Access Compliance Report

Public Rights-of-Way

Intersection ID: 30009	Main Street: BACKWATER_DR	Cross Street: OLD_CAROLINA_DR	Location: E
ADA ID: 39852377A11A	Ramp Type: PerpDiag	Initial Pass/Fail: Fail	Overall Compliance: No
			Severity Score: 21.25

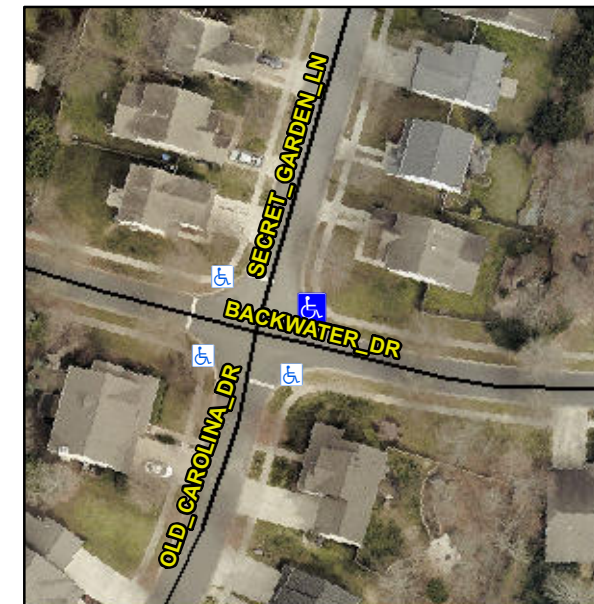
Not Found, R304.5.1, R304.5.3

Compliance	Description	Data	Compliance	Description	Data
N/A	Ramp Length (in)	48.0	Yes	Ramp Slope (%)	6.1
No	Ramp Width (in)	47.5	No	Ramp XSlope (%)	6.6
N/A	Flare Type LT	N/A	N/A	Flare Type RT	N/A
N/A	Flare Slope LT (%)	N/A	N/A	Flare Slope RT (%)	N/A
N/A	Flare Traversable LT?	N/A	N/A	Flare Traversable RT?	N/A
N/A	Landing Length (in)	N/A	N/A	DWS Provided?	N/A
N/A	Landing Width (in)	N/A	N/A	DWS Contrast?	N/A
N/A	Landing Slope (%)	N/A	N/A	DWS Length (in)	N/A
N/A	Landing X Slope (%)	N/A	N/A	DWS Full Width?	N/A
N/A	Landing Curb? (Y/N)	N/A	N/A	DWS Offset (in)	N/A
N/A	Shared Landing?	N/A			
N/A	Gutter Ponding?	N/A	N/A	Gutter Slope (%)	N/A
N/A	Gutter Lip Ht (in)	N/A	N/A	Gutter X Slope (%)	N/A
N/A	Painted X Walk1?	No	N/A	Painted X Walk2?	No
	X Walk 1 Direction	To NW		X Walk 2 Direction	To SW
N/A	X Walk 1 Width (in)	N/A	N/A	X Walk 2 Width (in)	N/A
	X Walk 1 Slope (%)	0.5		X Walk 2 Slope (%)	3.1
	X Walk 1 X Slope (%)	4.5		X Walk 2 X Slope (%)	1.1

Remove & Replace Curb Ramp With Two New Directional Ramps or Equivalent.
